From: Kristin Anderson <Kristin.Anderson@floydsnider.com>
Sent: Friday, May 29, 2026 3:03 PM
To: Seeds, Tena (ECY)
Cc: Kim Hempel; Meg McCann
Subject: Time Oil Bulk Terminal well network update plan
Attachments: Revised TOC well replacement plan-ECY 5.26.pdf; A.2 Monitoring Well Status Summary.pdf; A.3b Proposed Short-Term PMP-Redevelopment.pdf

Long-Term Compliance Monitoring Annual Report
Appendix A: 2025 Groundwater Monitoring Annual Report
Time Oil Bulk Terminal
Seattle, Washington

Figure A.9
Monitoring Locations and
Proposed Monitoring Well Network Updates for 2026

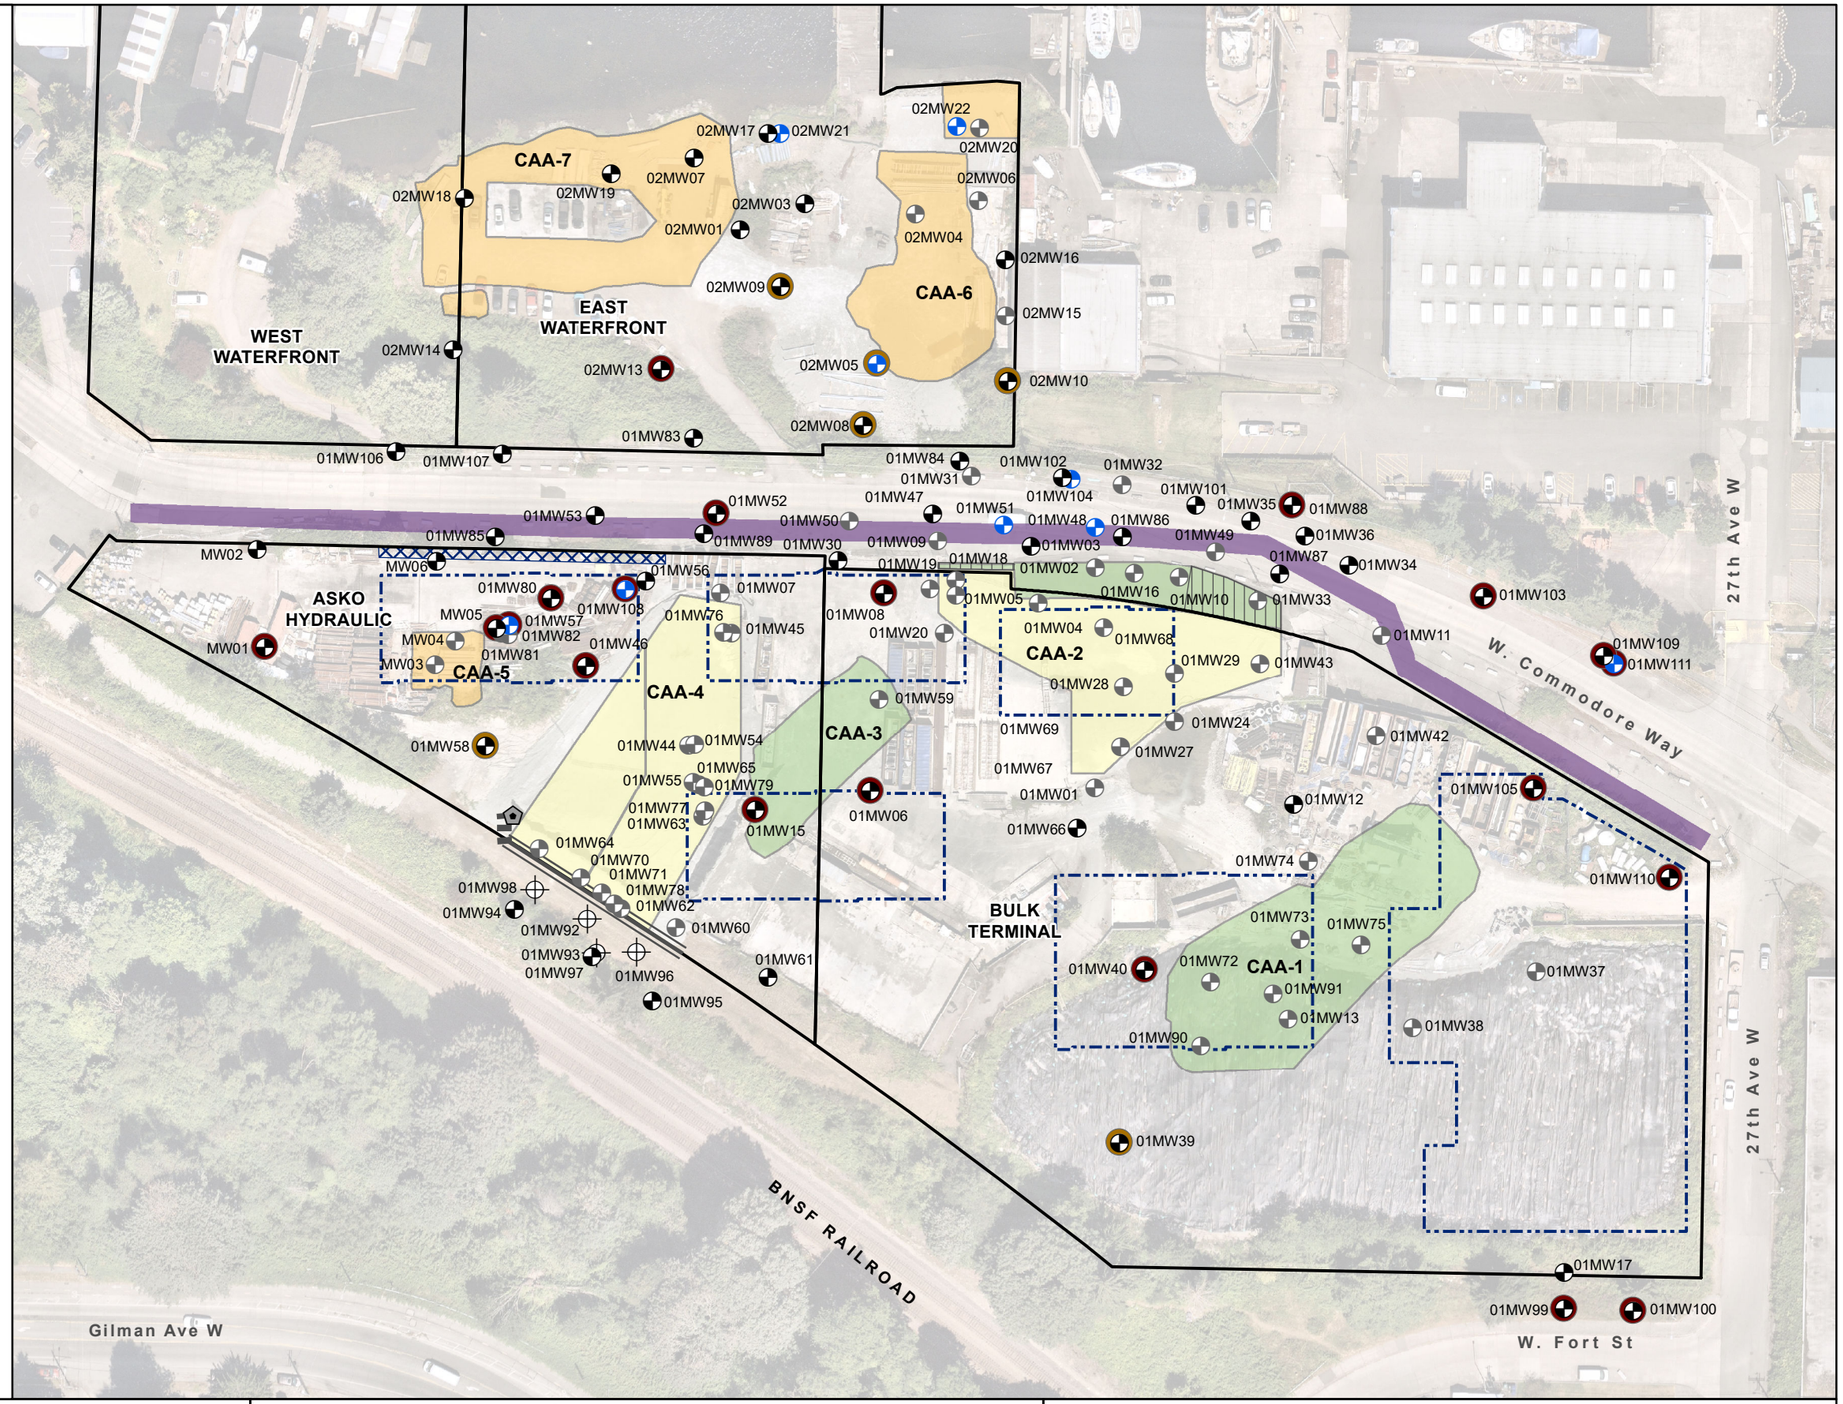
- Q1 2026 results show continued progress toward CULs for TPH and benzene at the CPOC
- A planned building on this parcel (building C) will be situated over most of CAA-1 and will also extend west of CAA-1
- 01MW40 (beneath building footprint) will be decommissioned as anticipated in the GMP
- The available area for 01MW90R may be too far west of CAA-1 to obtain useful attenuation data; 01MW12R to the north of CAA-1 is proposed as an appropriate on-property replacement to monitor attenuation.

- Q1 results show ongoing source control issues for TCE. TCE was also newly detected at 01MW106 downgradient of the CPOC (well was last monitored during the RI)

- A planned building on this parcel (building A) and stormwater detention structure will be situated over most of CAA-4
- 01MW15, 01MW46, 01MW57, 01MW80, 01MW108 and MW05 (beneath building footprint) will be decommissioned as anticipated in the GMP. 01MW56 and MW06 are also beneath or too close to planned structures and require decommissioning.

- Two replacement performance wells are proposed on-property upgradient of the CPOC, consistent with the GMP. After Ecology discussion last week and observed results at 01MW106, these wells are shifted west to intercept the current TCE plume and include 01MW80R and MW04R.

- Upgradient performance well 01MW60R will be installed consistent with the GMP
- Planned performance well 01MW45R is beneath a building footprint. The monitoring purpose of this well, which is intended to intercept potential TCE flowing from upgradient, will be served by 01MW60R

- Planned contingency performance well 01MW46R is also beneath a building footprint. 01MW46 is in a likely stagnation area adjacent to the ISS monolith and not a priority location for continued performance monitoring

01MW80R
CAA-4 upgradient of plumestop

MW04R
CAA-4 upgradient of plumestop, possible TCE flow path from BNSF

Recommended BNSF well at SW corner of monolith

01MW60R - CAA-4 upgradient plume

01MW12R- downgradient portion of CAA-1 Source area

Decommission prior to construction

Protect during construction (shown for wells near structure footprints for clarity)

Install following earthwork
